ORDERS UNDER SECTION 96 (2) OF ACT III OF 1910.

With reference to his application dated 27th Feb 1913,Mr. Karimdas P. Singh is informedthat the plan submitted by him for building Temple & Schoolon plot No. 2 Survey Sheet 1-5situate in Lahore Street London

We beg to inform you that I intend building a temple & School on plot No. 3
 Survey Sheet No. E, 5 Situate in Lawrence Road
 Street Garden Quarter.

—Plan showing the additions & alterations—
 —to be made on plot N^o. 3, E. 5.—
 —Garden Quarter—
 —Scale 8"=1 inch.—

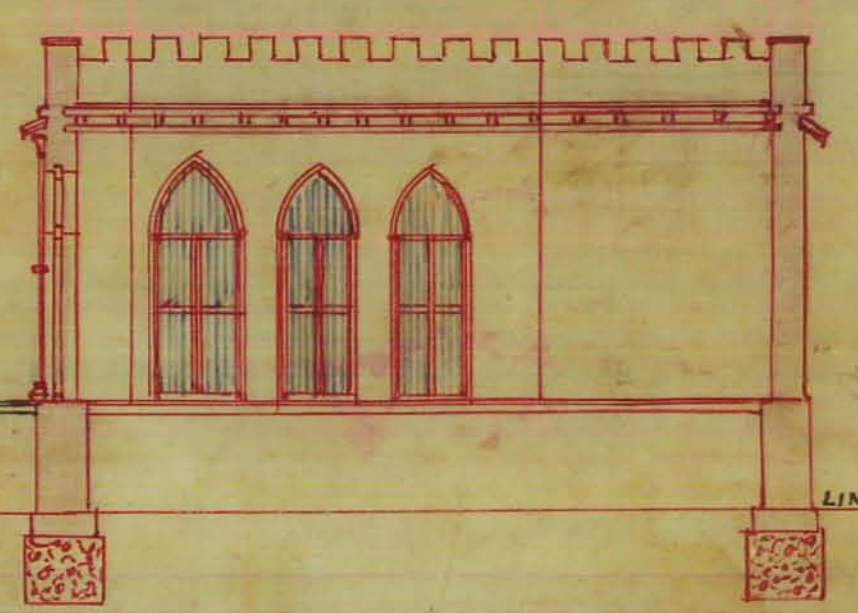
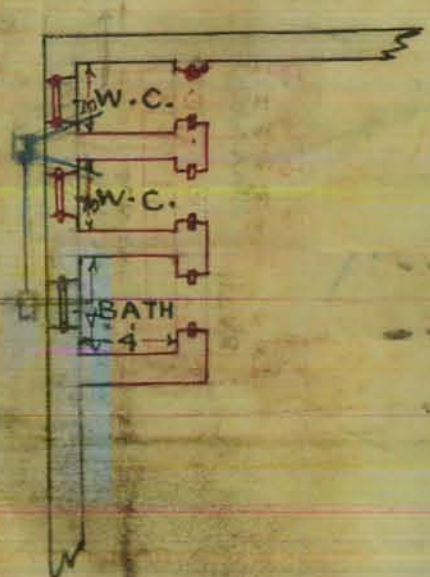
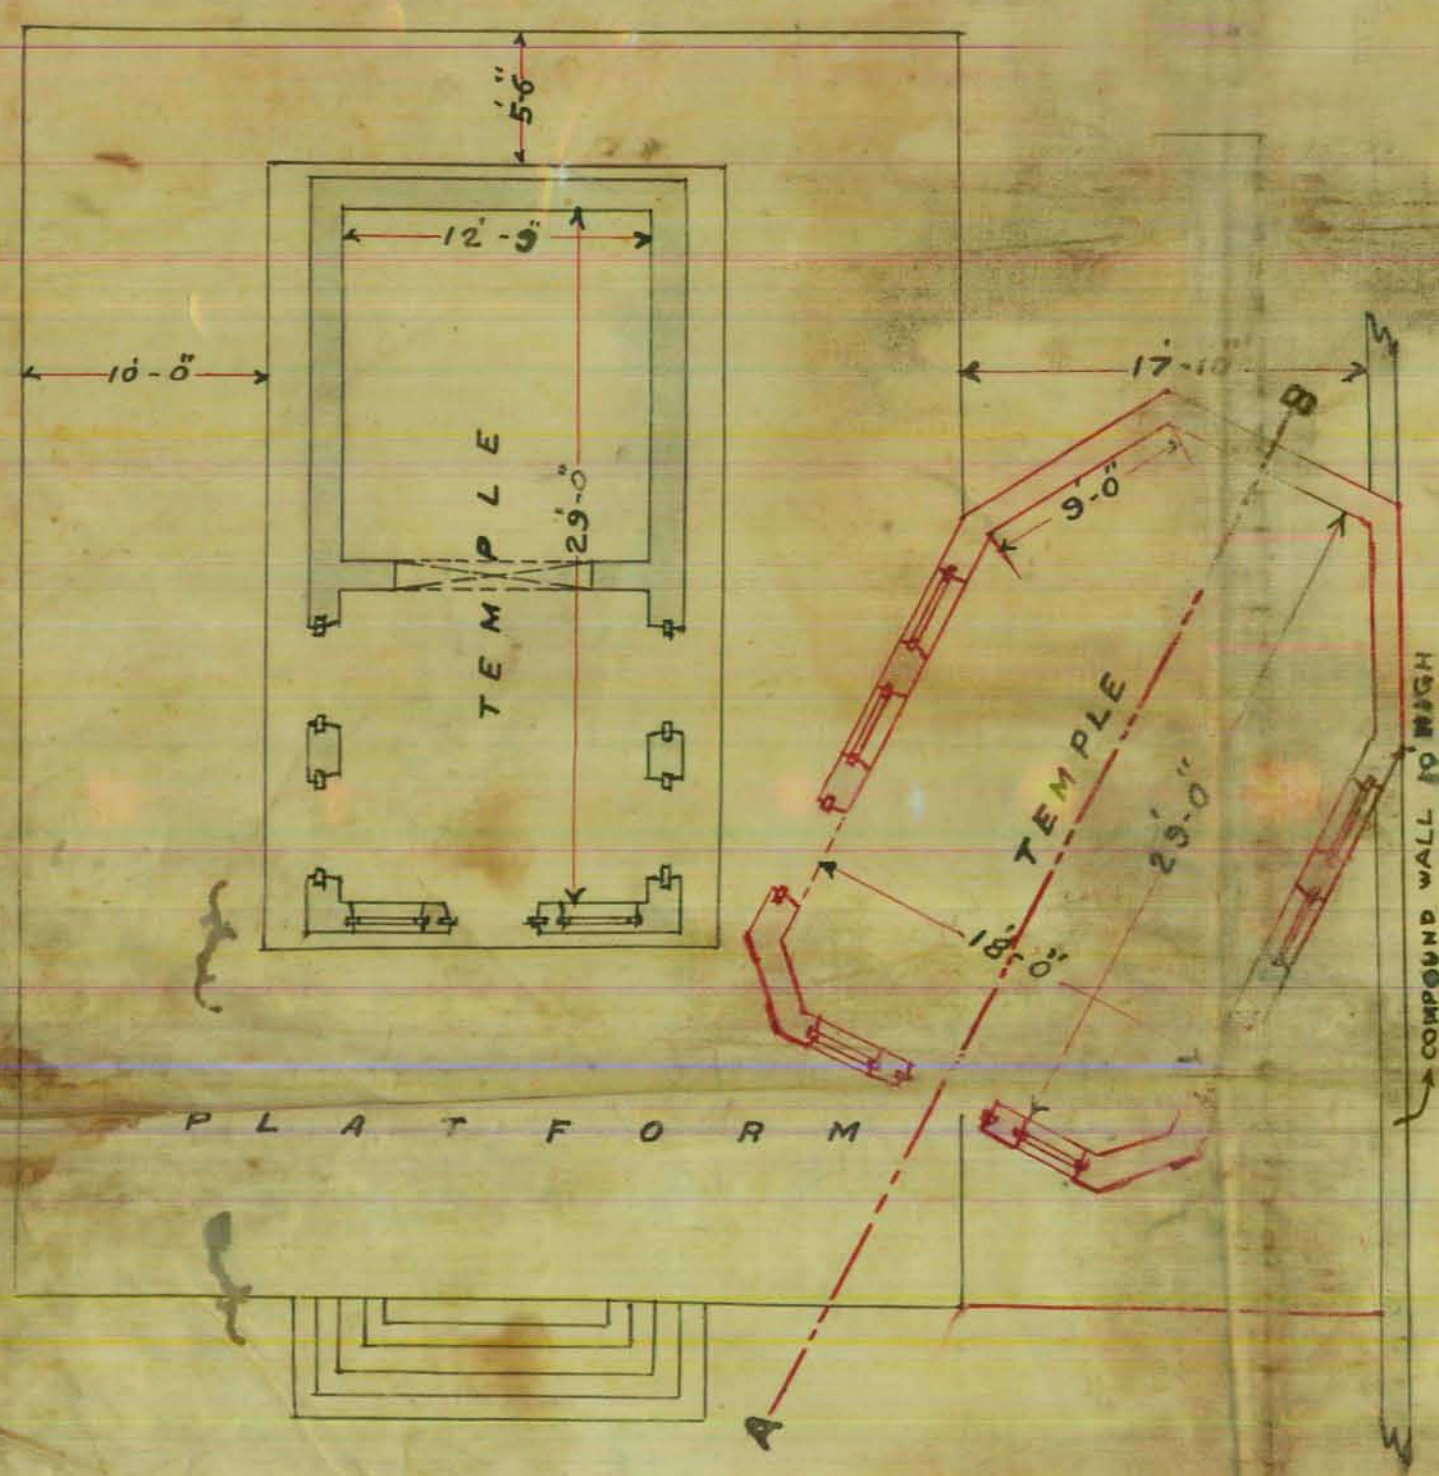
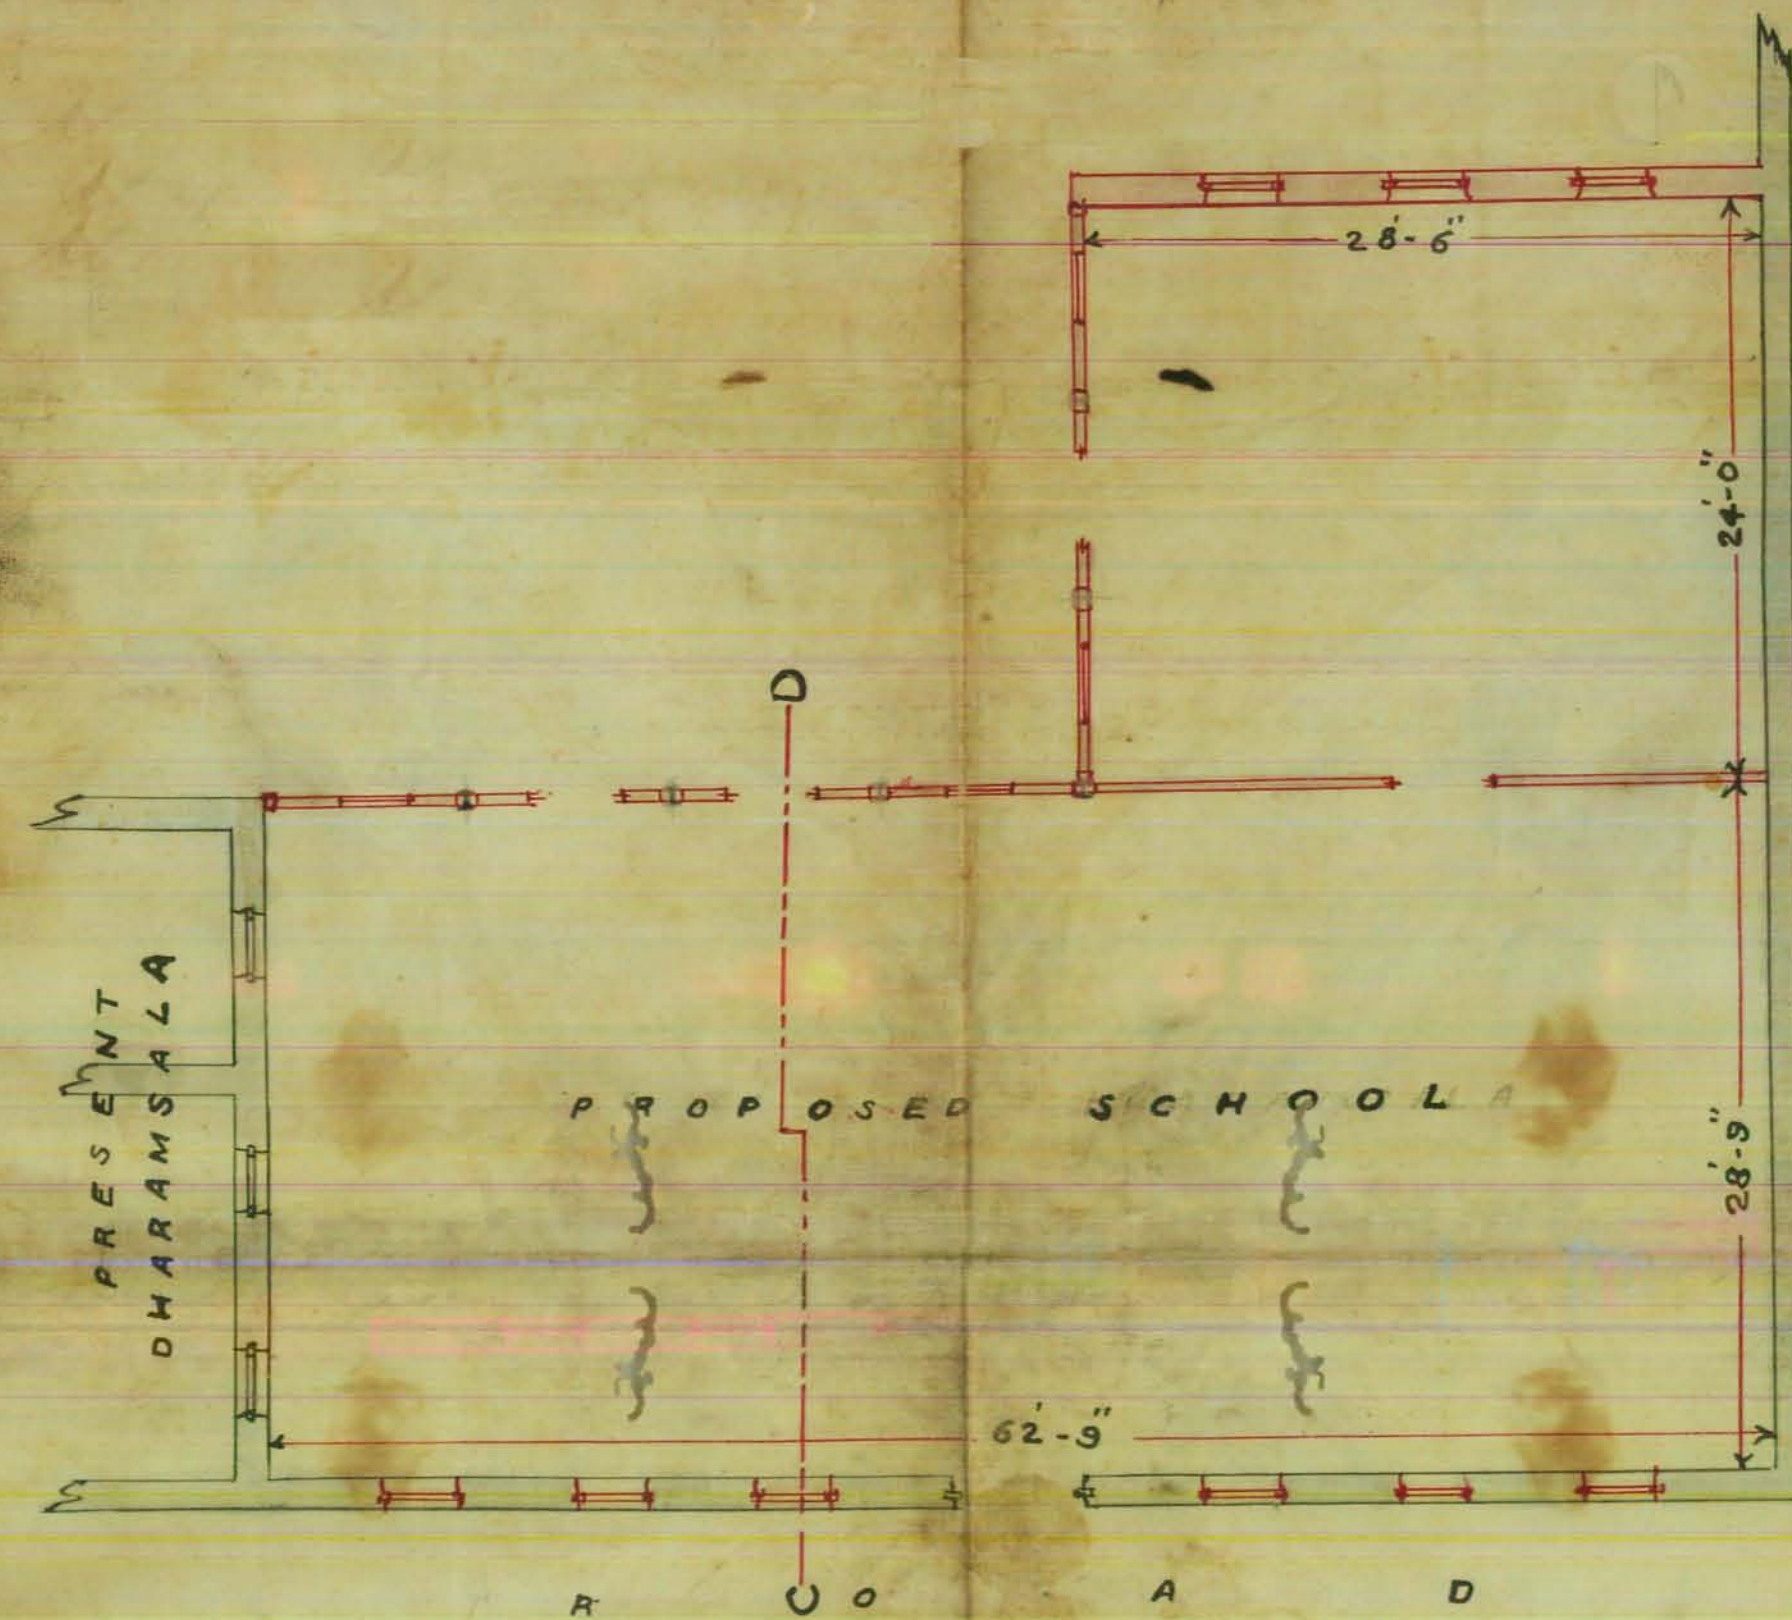
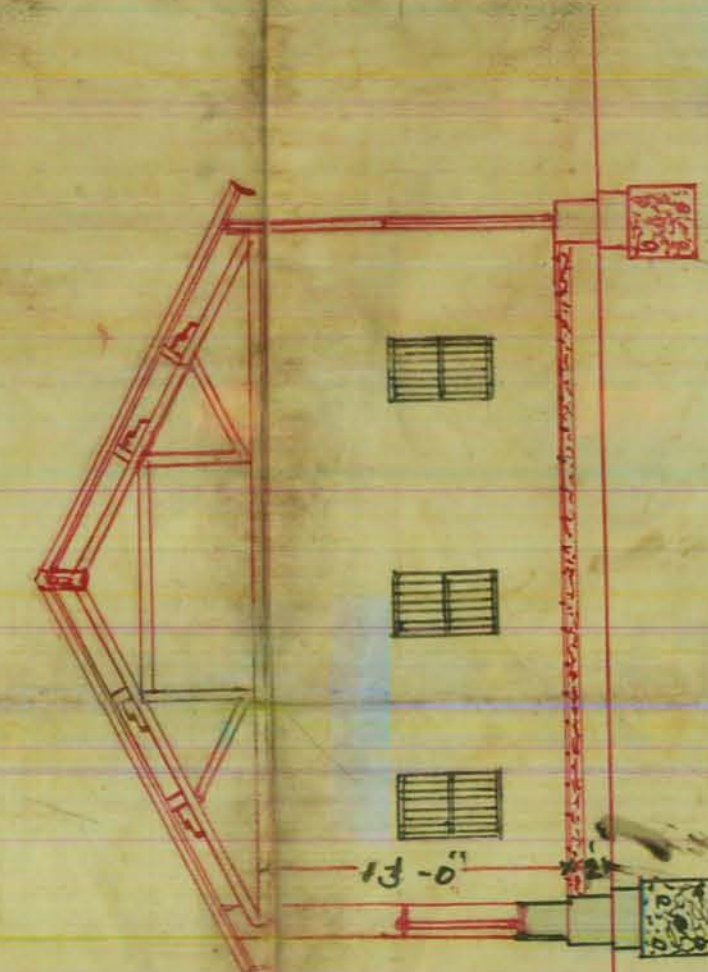
With reference to your No.2137 dated 15th ultimo
I have the honour to inform you the Municipality have no
objection to a temple being built according to the plan, pre-
vided the privies shown are substituted by water closets
and bath accomodation provided.

Kursondas Premji owner of plot No.3, E-5,
Lawrence Road ^{Garden} ~~residential~~ quarter is informed a privy will not
be allowed on the plot. Arrangements must be made to sup-
ply water closets and bath for conveniences.

*Privies cannot be allowed
H. C. must be provided*

Private cannot be
allowed. D.S. should
be provided
27/12 W. S. Kroff

2/- The privies have been substituted ^{for} by water closets and
 both accomodation have also been provided.
